Memo No. 247(7) - I  
I/4M-98/2011

Sub: Amendment of Lining Manual.

**MANUAL FOR LINING IN  
IRRIGATION CANALS IN  
WEST BENGAL  
(1<sup>st</sup> Amendment)**

## Preface (1<sup>st</sup> Corrigenda & Addenda)

REVISION DRG. NO. -MISC/1092/1/2/(R-1)/19 DATE- 10-07-2019 SHEET - 1/2

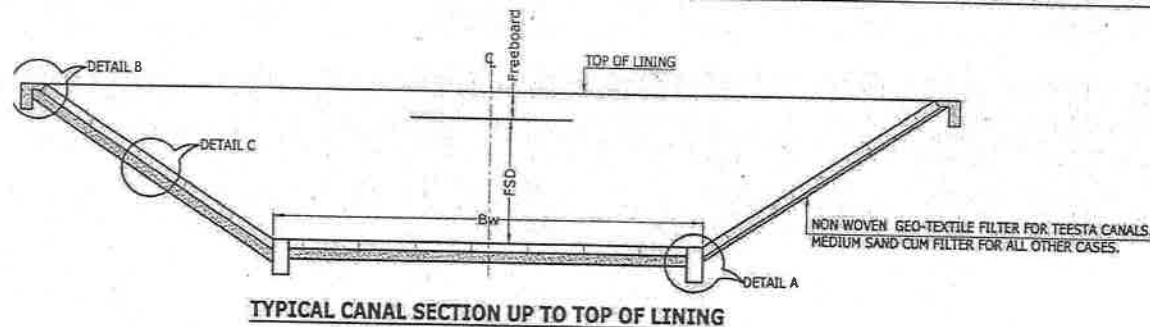
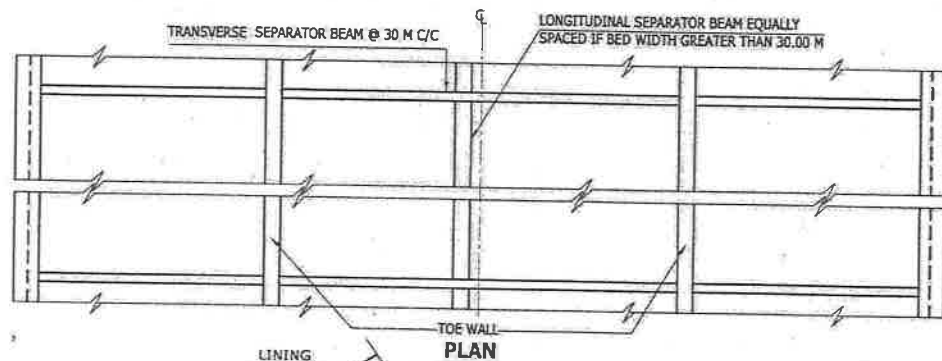
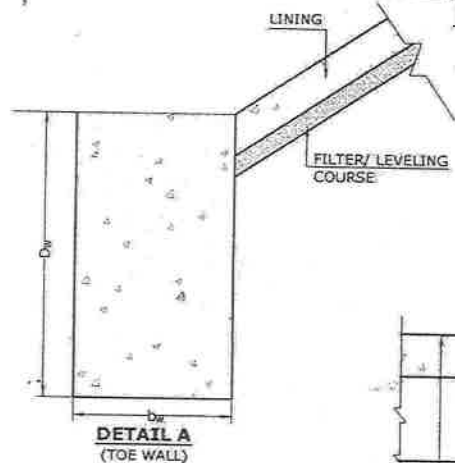
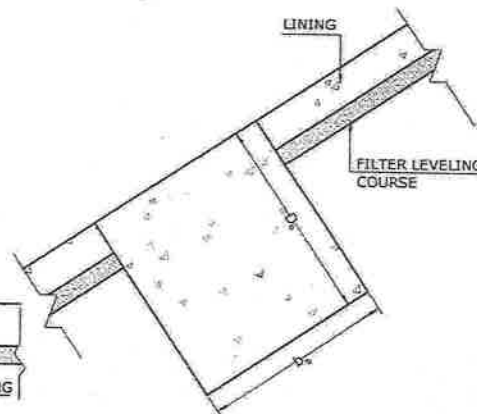
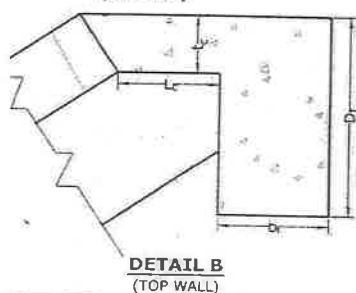
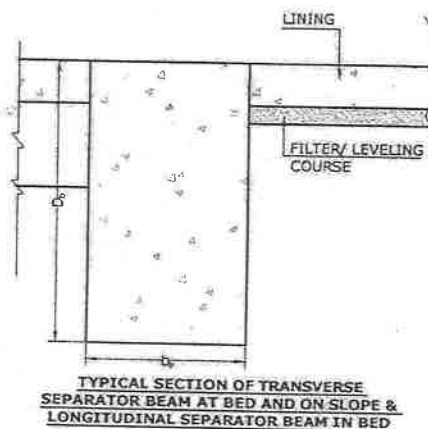
- 6.0 Various parameters as shown in the enclosed Drawing No. **Misc/1092/1/2/(R-1)/19** and Drawing No. **Misc/1113/1/1/19** of the Central Design Office, Irrigation & Waterways Directorate, have been recommended, which are to be selected following a step by step approach as stated below:
- 6.1 Type (i.e. cast-in-situ or precast) of lining, recommended thickness, plan dimension / area and Free Board (FB) above Full Supply Level (FSL) are to be determined from Table-1 (Modified), for categories of subgrade soil condition. These parameters would be independent of soil characteristics and accordingly would be the same for all projects, irrespective of the location districts. Plain Cement Concrete (PCC) lining is recommended considering the aspects of strength, durability, easier reparability and
